This proposal requests approval of the Final Plan/Plat for the sixth filing of **The Knolls Subdivision** located approximately 1,000 feet south of Cortland Avenue, along the east side of 27½ Road. The last four filings, Filings #4 through #7, of **The Knolls Subdivision** are part of a Planned Residential development with a zoning of PR-2.5. The developed area of Filing #6 is approximately 15.5 acres in size and is made up of 19 single family lots and one open space tract approximately 0.7 acres in size intended for stormwater detention. Filing #6 is in accordance with the approved Preliminary Plan which was approved by the Grand Junction Planning Commission on July 18, 2000.

Request approval of the Final Plan/Plat for 15.5 acres to develop 19 Single Family lots and one open space tract in a PD (Planned Development) zone.

# Review Agency Comment Sheet

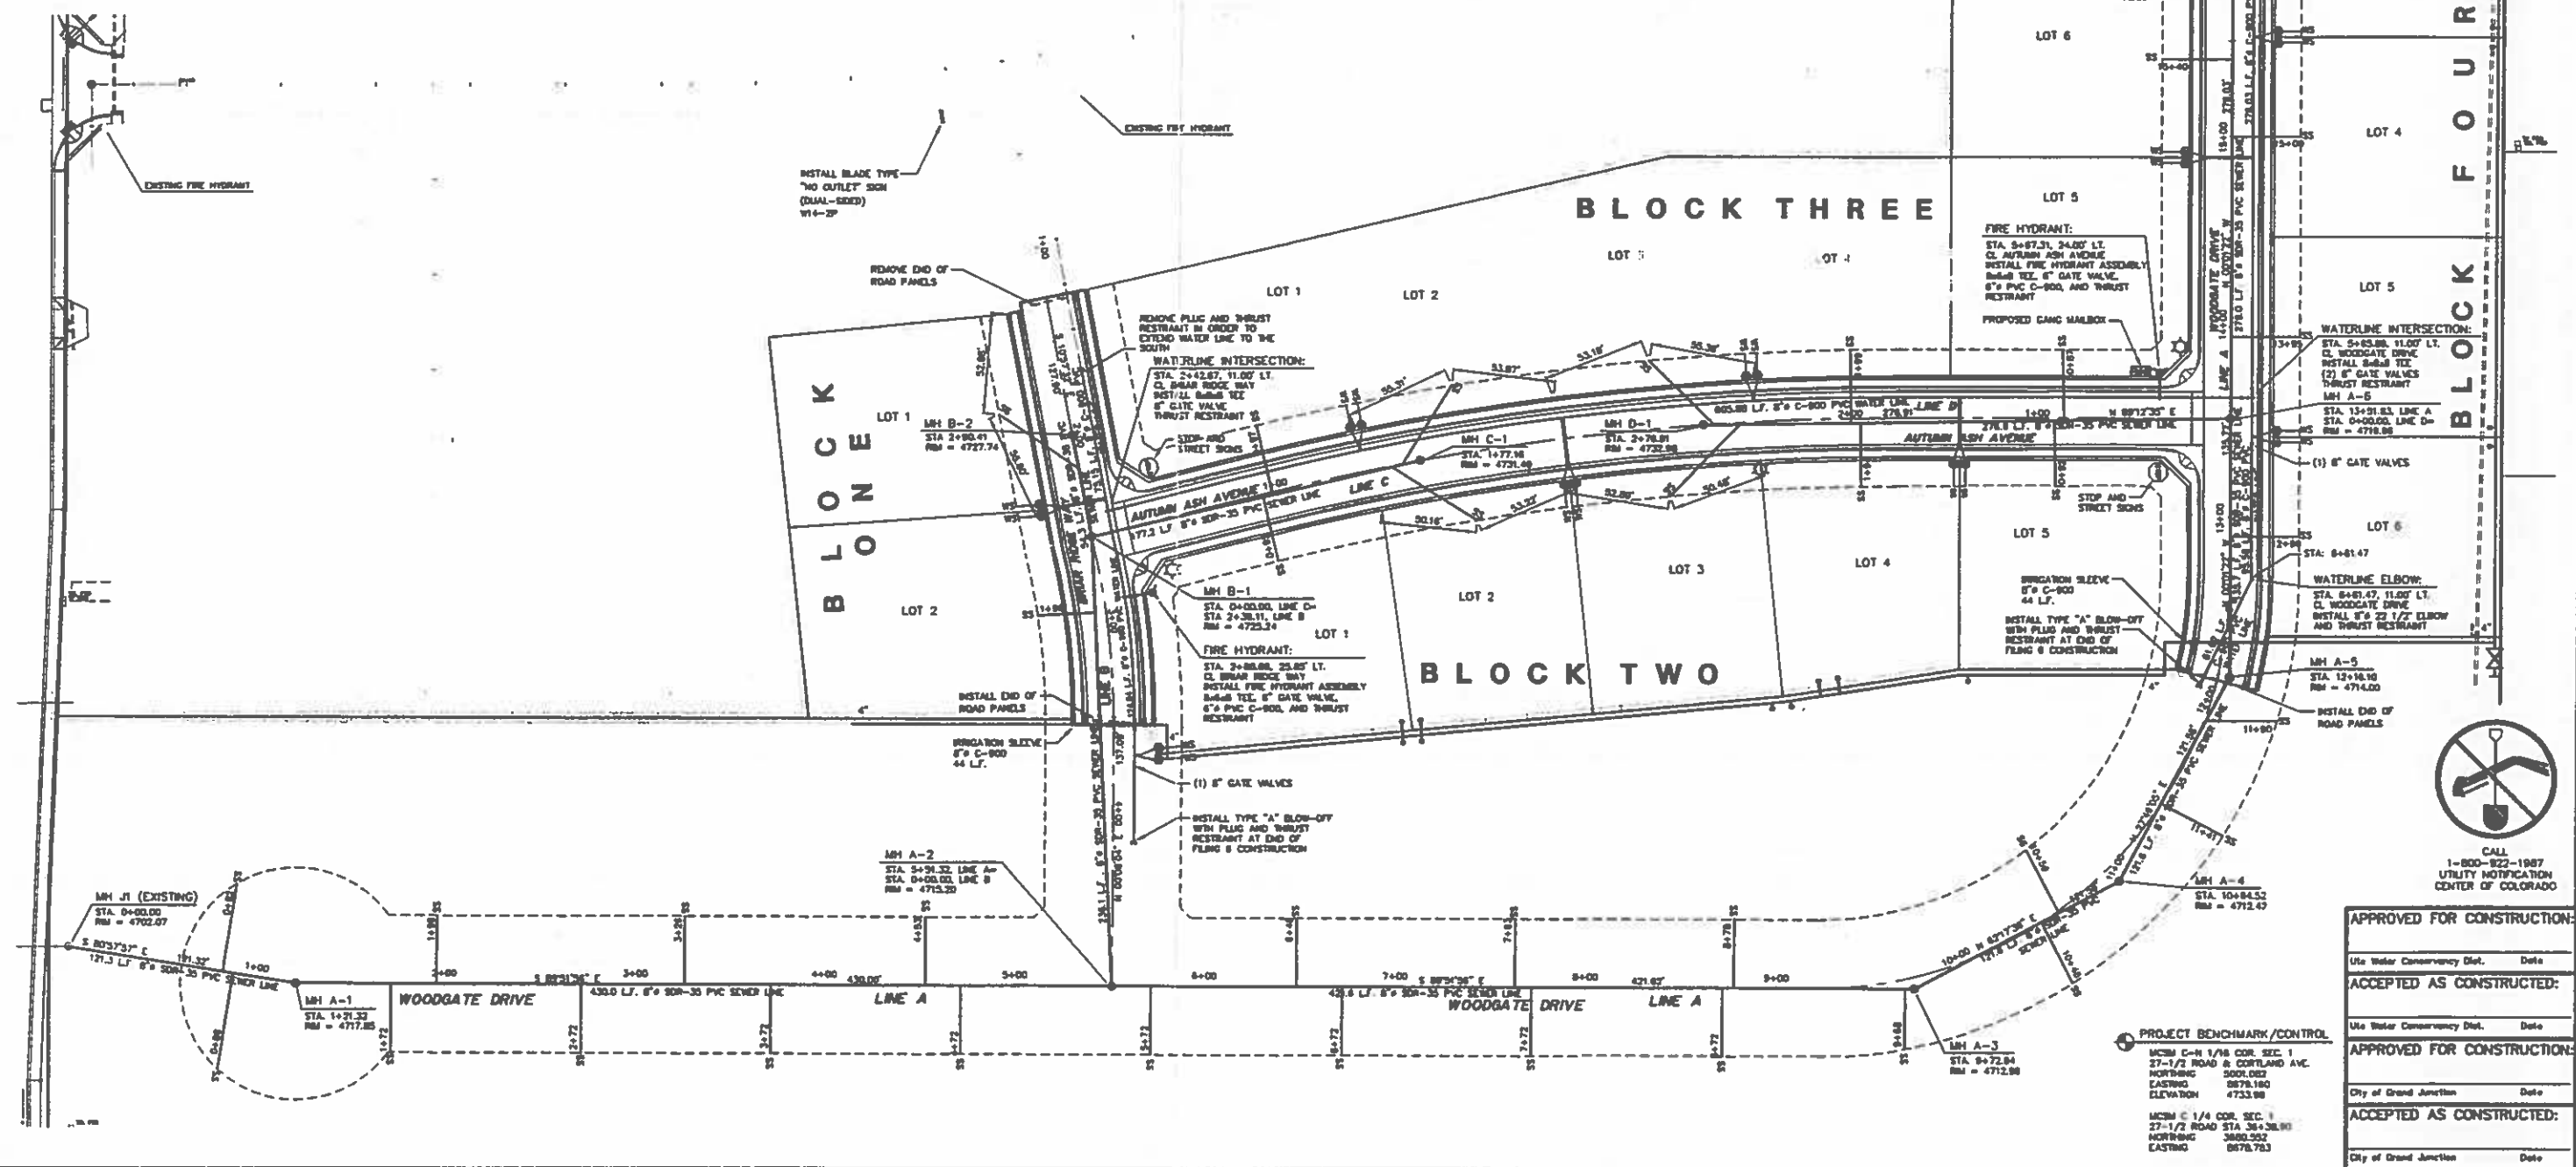
1. As requested in the 5-03 comments (#1), blade type "no outlet" were to be provided. They are shown on the plan set (5 of 20), but are not located correctly. These signs are to face approaching Piazza traffic to be effective. Each assembly will involve 2 signs (one facing each approach, at each intersection).
2. The requested note (see note one from the 5-03 comments - "Add note to sheet 5 of 20 that "City Traffic Operations Supervisor to be contacted (970/244-1573) prior to any

1. There will need to be blade type "no outlet" advisory signs posted on both Briar Ridge and Fairwood Pl. at Piazza Wy, if not already provided. Add note to sheet 5 of 20 that "City Traffic Operations Supervisor to be contacted (970/244-1573) prior to any signing material order or installation.
2. There are no internal Urban Trails concerns for this site. A bike lane will be required along the site's 27 ½ Rd frontage, however.
3. Traffic calming will be required on Briar Ridge, Woodgate, and Autumn Ash. Intersection calming (such as restricted widths on all three legs) will work well on Briar Ridge and on Woodgate. Mid-block calming, such as a chicane or width restriction, will be required on Autumn Ash. For future reference, additional calming will be required on Woodgate (between Autumn Ash and Briar Dr) in phase 7. Call 256-4123 for design guidelines.

1. Blade-type "No Outlet" signs, per our 9/25/03 meeting, are now shown on the revised drawings. Thank you for the input.
2. The note has been added to sheets 5 and 16, as requested.
3. Traffic-calming for Filing 6 will consist of the chicane proposed on Autumn Ash Avenue (see sheet 16), as discussed and approved. This is reflected in the revised drawings.
4. The curb-top reflectors have been added and are indicated on the Sheet 16 of the revised plans.

DESCRIPTION	BY	DRG	O.P. DEVELOPMENT CO., LLC	GRAND JUNCTION, COLORADO	SCALE: 1" = 60'	JOB NO: 4003.06-09	DATE: 4-09-03
<b>GRADING PLAN THE KNOLLS SUBDIVISION, FILING 6</b>				<b>17 of 20</b>

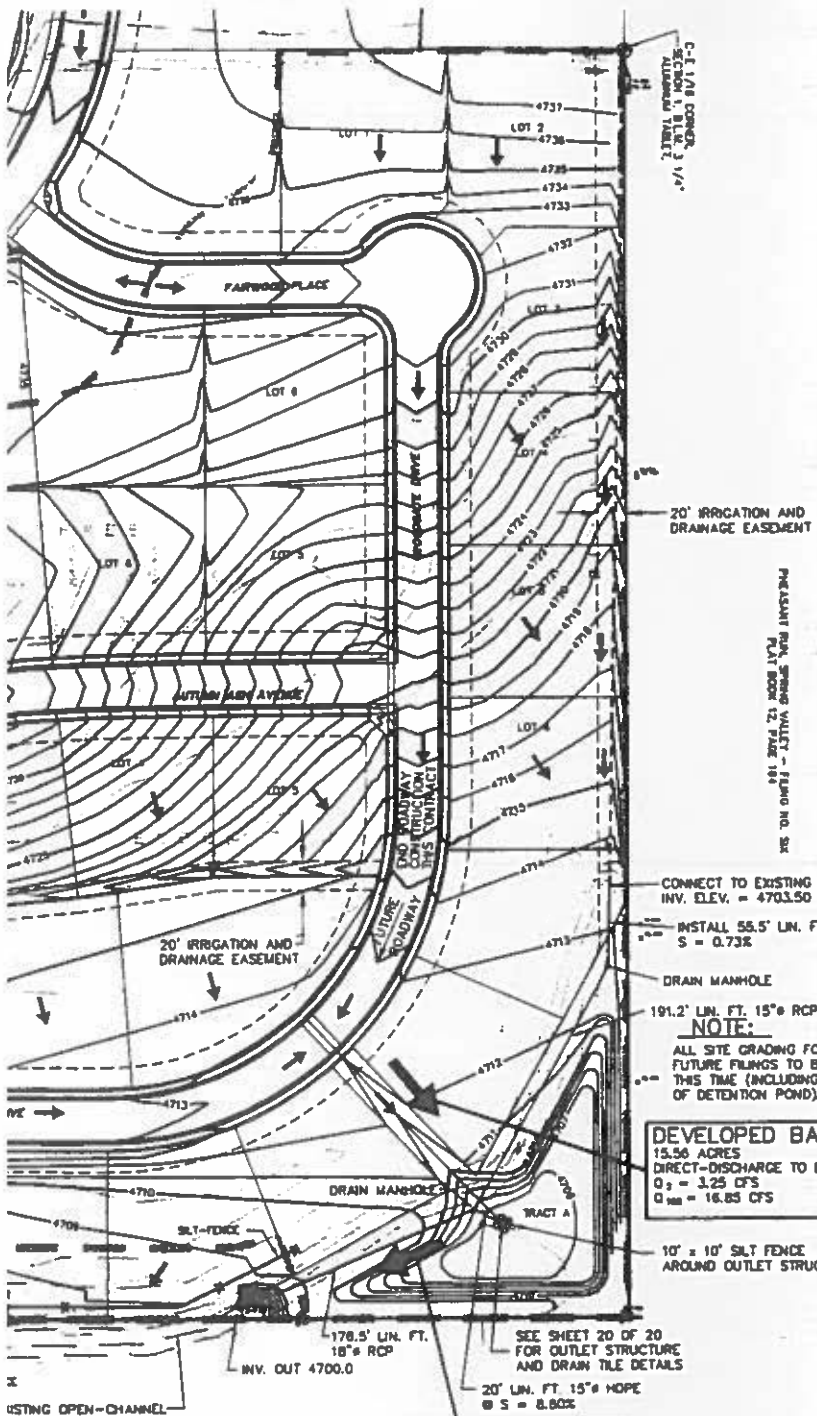
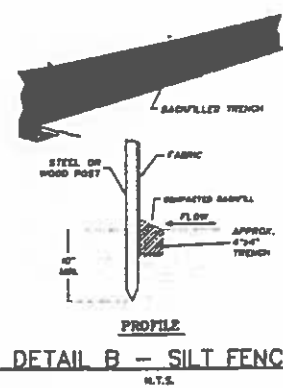
9. Please see the attached redline drawings with minor comments. Respond to each comment in a different color and return with the written response.
10. *The grading plan has a table for top of concrete elevation. The grading administration regulation requires minimum and maximum finished floor elevations.*

*Are the top of concrete elevations the only elevations are is there flexibility? Make this conform to the reference regulation. THIS ORIGINAL COMMENT STILL STANDS.* The County is not the entity that gets the phone call when a higher lot drains onto a lower lot and it causes the owner headache or damage. The highest elevation is to ensure that houses on adjacent lots don't get constructed at radically different elevations that preclude proper drainage.

DESCRIPTION	BY	DATE	OP DEVELOPMENT CO., LLC	GRAND JUNCTION, COLORADO	SCALE: 1" = 60'	JOB NO. 4003.06-02	DATE: 4-08-03
<b>STORMWATER MANAGEMENT PLAN</b>				<b>THE KNOLLS SUBDIVISION, FILING 6</b>			
							<b>18 of 20</b>

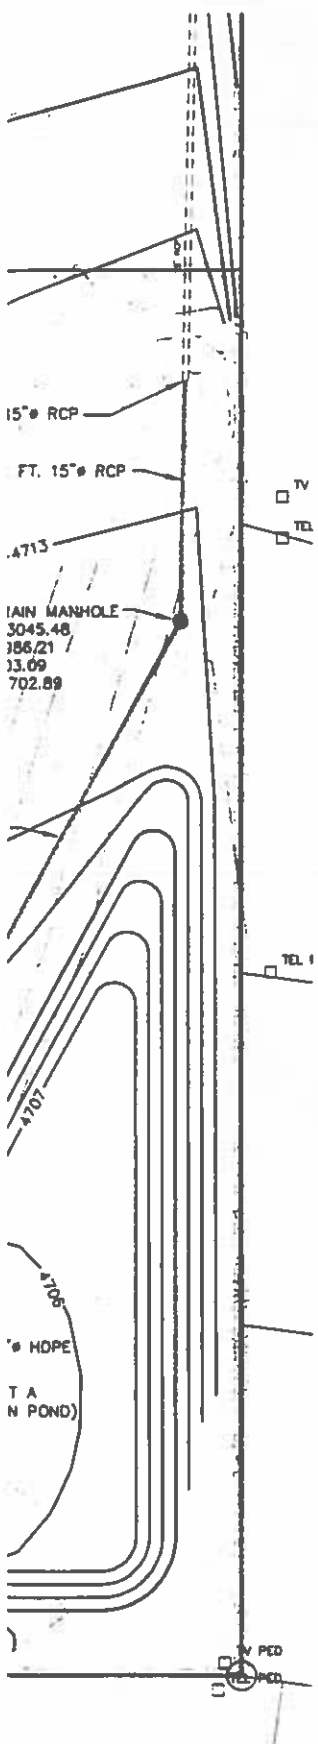
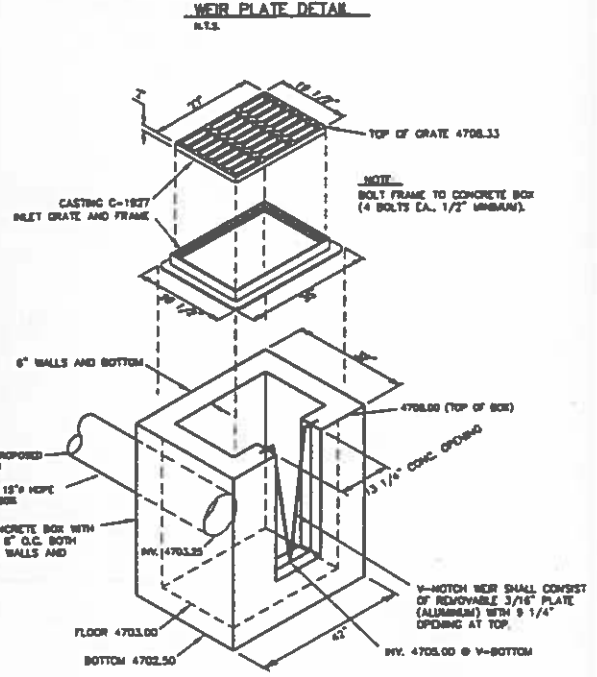
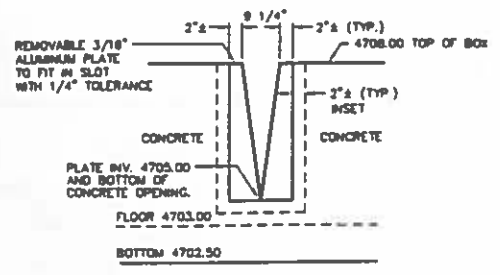
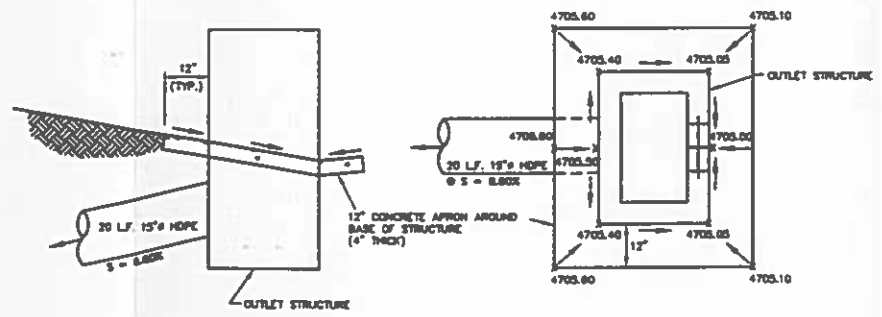
4. On sheet 18, in the plan portion at the retention pond pump it still calls out the pump as 60GPM. Please revise to 90. I assume you have the pump in a sump and automatically controlled.
5. How are you discharging the water into 27 ½ Road? Is it piped to top back of walk? Probably need to provide a detail or describe in a note. Should stop pipe a little distance back of walk and concrete to BOW.

3. The sump-pump in the retention pond has been upgraded to discharge 90 gpm to 27 ½ Road to be capable of evacuating the 100 year volume (34,028 cubic-feet, see sheet 18) in less than 48 hours.
4. The construction plans for the piping of Drain D were not prepared as part of the improvements for Filing #6 but rather were prepared as an independent project working with the Grand Valley Water Users Association. As requested, we have recently provided a set of these plans to the City.
